Device Errata

NL-SW-HSPA Skywire[®] Modem

NimbeLink // Products
Published // May, 2018

Figure 1: The location of the serial number.

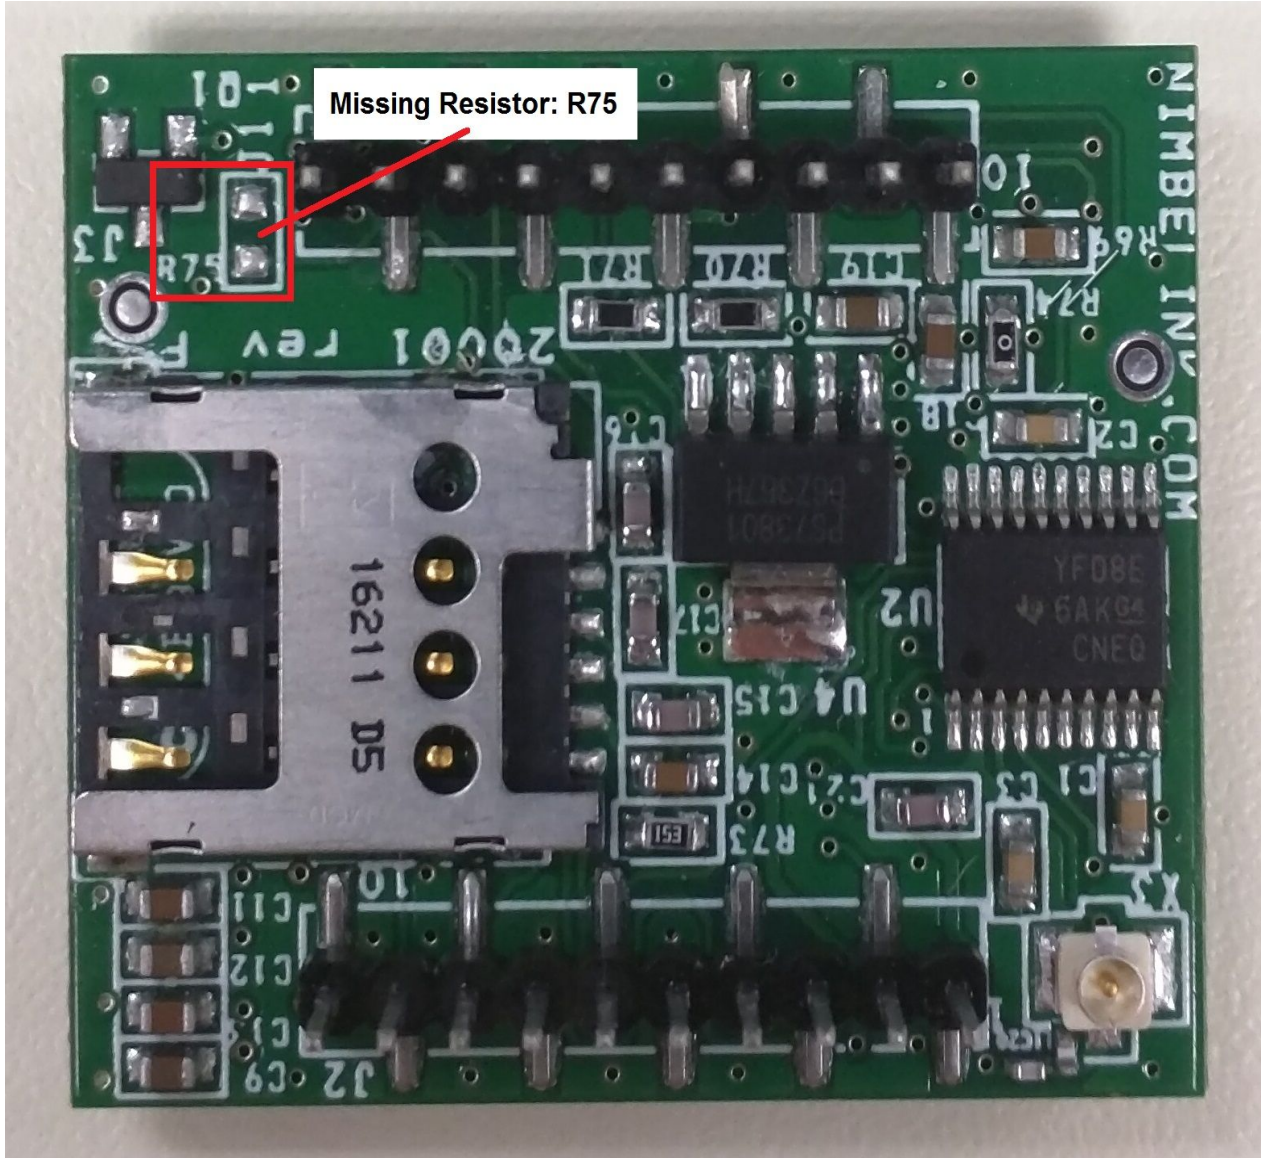
To determine if an NL-SW-HSPA modem is affected by this error, please locate the serial number starting with “BTW” on the label attached to the top of the device. If the first 9 digits of the serial number lie in the range: BTW 308430001 through BTW 308430589, then the modem is affected.

Please refer to figures 1 and 2 for the locations of the serial number and missing resistor, respectively.
